# HISTORIC AND DESIGN REVIEW COMMISSION

February 03, 2021

**HDRC CASE NO:** 2021-027  
**ADDRESS:** 520 LEIGH ST  
**LEGAL DESCRIPTION:** NCB 2739 BLK LOT 4F & PT OF 5F (AKA TRACT 6)  
**ZONING:** IDZ,H  
**CITY COUNCIL DIST.:** 1  
**DISTRICT:** Lavaca Historic District  
**APPLICANT:** LABOR STREET COMMONS LLC  
**OWNER:** LABOR STREET COMMONS LLC  
**TYPE OF WORK:** Construction of a 2-story residential structure, site modifications  
**APPLICATION RECEIVED:** January 15, 2021  
**60-DAY REVIEW:** Not applicable due to City Council Emergency Orders  
**CASE MANAGER:** Stephanie Phillips

The applicant is requesting final approval to construct a new 2-story single family residence at the lot addressed 520 Leigh St. Some of the schematic documents include conceptual information about a new 3-story multifamily residential structure in the center-rear of the lot addressed 606-608 Labor St, as well as renovation work and rear additions to three 1-story historic structures on the same parcel, two of which are located along the Labor St frontage. These scopes are not included in the current request.

**Rendering looking Northeast from Labor Street**

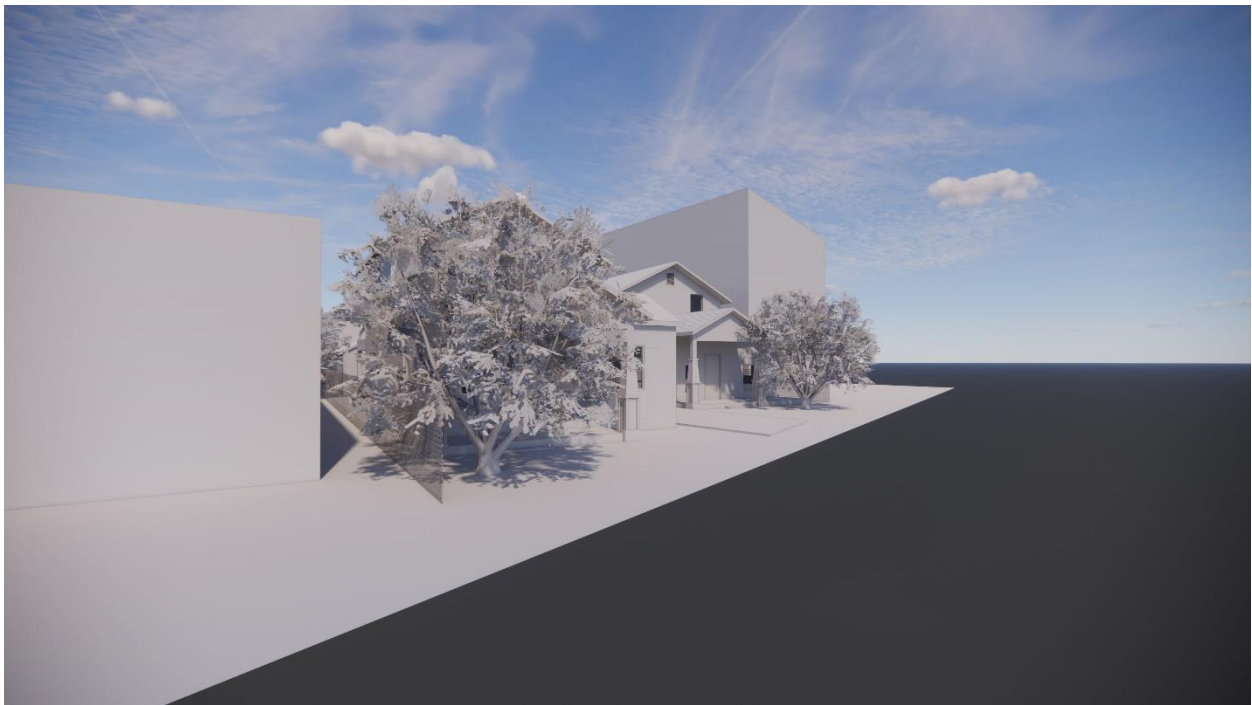
**STAFF NOTE: THE 2-STORY REAR ADDITIONS  
REPRESENTED ON THESE 1-STORY HISTORIC  
STRUCTURES ARE NOT EXISTING AND HAVE NOT  
BEEN REVIEWED OR APPROVED BY OHP OR HDRC**

**Rendering looking directly West from Labor Street**

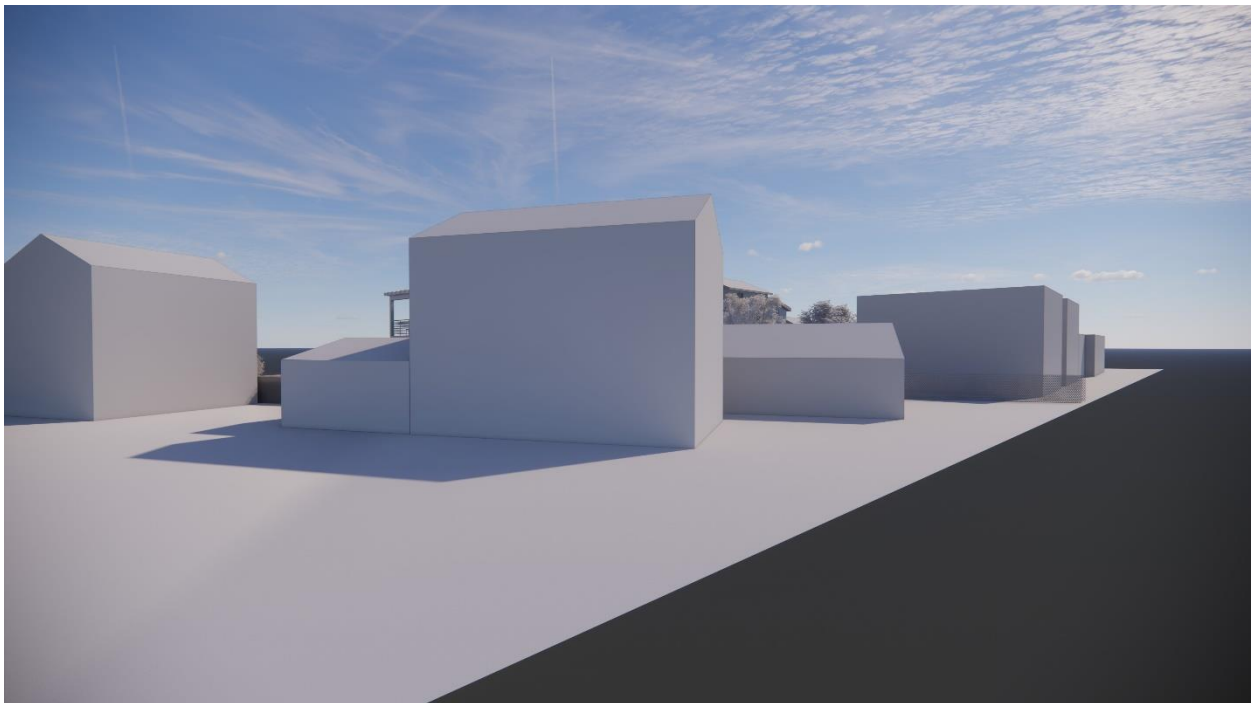
**STAFF NOTE: THE 2-STORY REAR ADDITIONS REPRESENTED ON THESE 1-STORY HISTORIC STRUCTRES, AS WELL AS THE 3-STORY STRUCTURE TOWARDS THE REAR, ARE NOT EXISTING AND HAVE NOT BEEN REVIEWED OR APPROVED BY OHP OR HDRC**
